NLS2002120
September 27, 2002

Subject: Response to Request for Additional Information Related to Nebraska Public Power District's Seismic Reevaluation Proposed to Address Cooper Nuclear Station License Condition 2.C.(6)
Cooper Nuclear Station, NRC Docket No. 50-298, DPR-46

ATTACHMENT 1

Figure 1. IPEEE RLE Floor Response Spectra for the Control Building

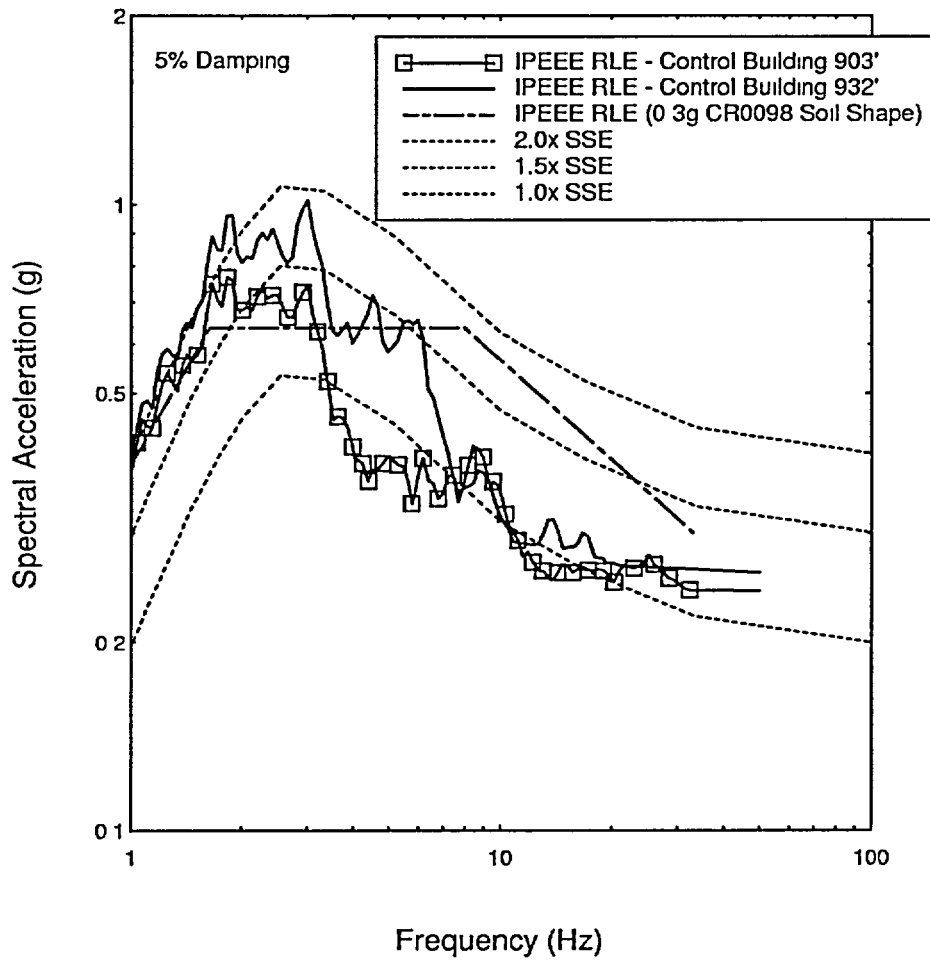
Question 1: *In your submittal (Reference 1), you indicated that the 2.0×SSE [safe shutdown earthquake] ground response spectrum (GRS) envelopes the floor response spectra (FRS) at elevation 932'-6" in both the Control Building (CB) and Reactor Building. However, Figure 4.5 shows that the FRS at elevation 932'-6" in the CB is higher than the 2.0×SSE GRS. Explain the discrepancy. Also, provide a figure, which confirms that the 2.0×SSE GRS envelopes the FRS at elevation 903'-6" in the CB.*

Notwithstanding this change, Figure 4.5 from EE 01-147, Rev. 0, submitted previously with NPPD's February 26, 2002 letter (Reference 2), has been revised to show the FRS for CB 903'-6" and is provided as Figure 1 to this response. Figure 1 shows that 2.0×SSE GRS completely envelops the FRS for CB 903'-6".

As noted in the Question 1, 2.0×SSE GRS does not completely envelop the FRS for CB 932'-6". However, 2.0×SSE GRS was judged to be an adequate estimate of the FRS at Turbine Building (TB) 932' because:

- Figure 1 shows that the points where the CB 932'-6" FRS is higher than 2.0×SSE GRS are relatively small, and occur in the low frequency regions, below about 2 Hz,
- Figure 2 shows that 2.0×SSE GRS is a conservative envelope of the RB 931'-6" FRS, and
- The CB and RB were developed using the Individual Plant Examination for External Events (IPEEE) Review Level Earthquake (RLE) which, as shown in Figure 3, has substantially more low frequency content than either the Cooper Nuclear Station (CNS) SSE or the Regulatory Guide 1.60 GRS. Even so, these conservatively calculated FRS are enveloped by the 2.0×SSE GRS in all but the low frequency region.

Figure 4. Comparison of Shear (V) / Tension (T) Interaction Curves

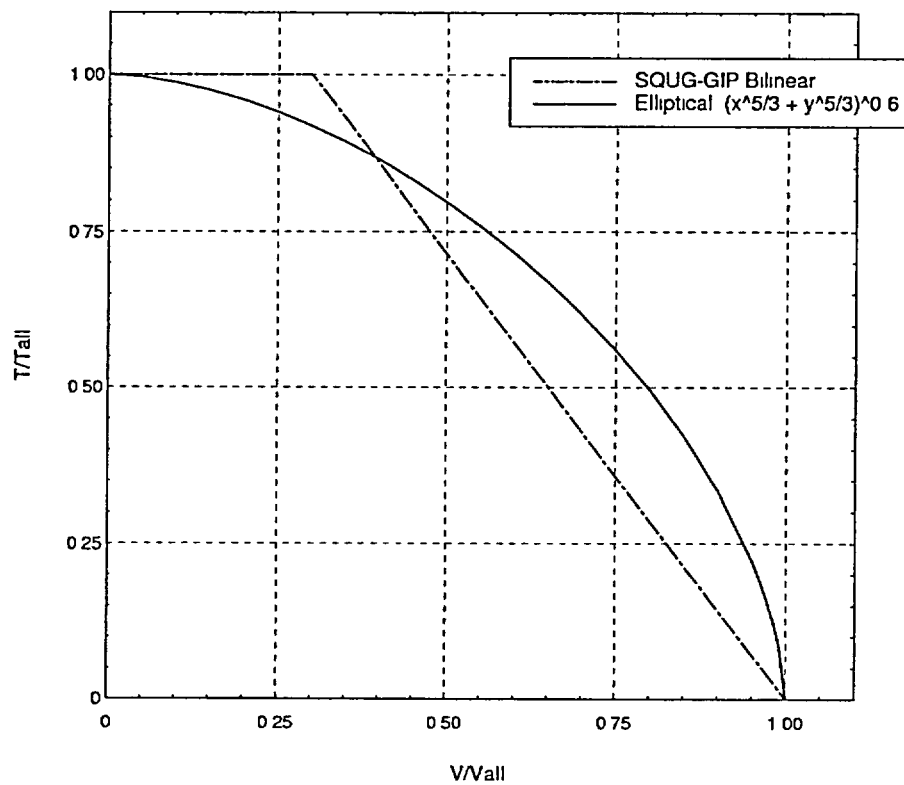
Question 5: *You used Equation 5.9 in Reference 1 [EE 01-147] for determining the adequacy of the anchor bolt capacity. Discuss how Equation 5.9 is more conservative than the bilinear formulation given in the SQUG-GIP (Reference 3).*

Response: NPPD has revised its methodology for evaluation of anchor bolt capacity. NPPD is now using the Bilinear Relationship employed in the SQUG GIP. NPPD will revise EE 01-147 to reflect this change.

The interaction curves for the Bilinear Relationship and the Power Law Relationship (EE 01-147, Equation 5.9) are shown in Figure 4 for comparative purposes. When the shear ratio (V/V_{all}) is less than about 0.4, the Power Law relationship, with $a = b = 5/3$ is more conservative than the Bilinear Relationship. When the shear ratio is greater than about 0.4, the Bilinear Relationship is more conservative. The CNS MSIV Leakage Pathway support anchor bolts were determined to be acceptable using both methods. However, NPPD will revise its methodology to use the Bilinear Relationship that has already been reviewed and approved by the NRC as part of the SQUG GIP, and update EE 01-147 accordingly.
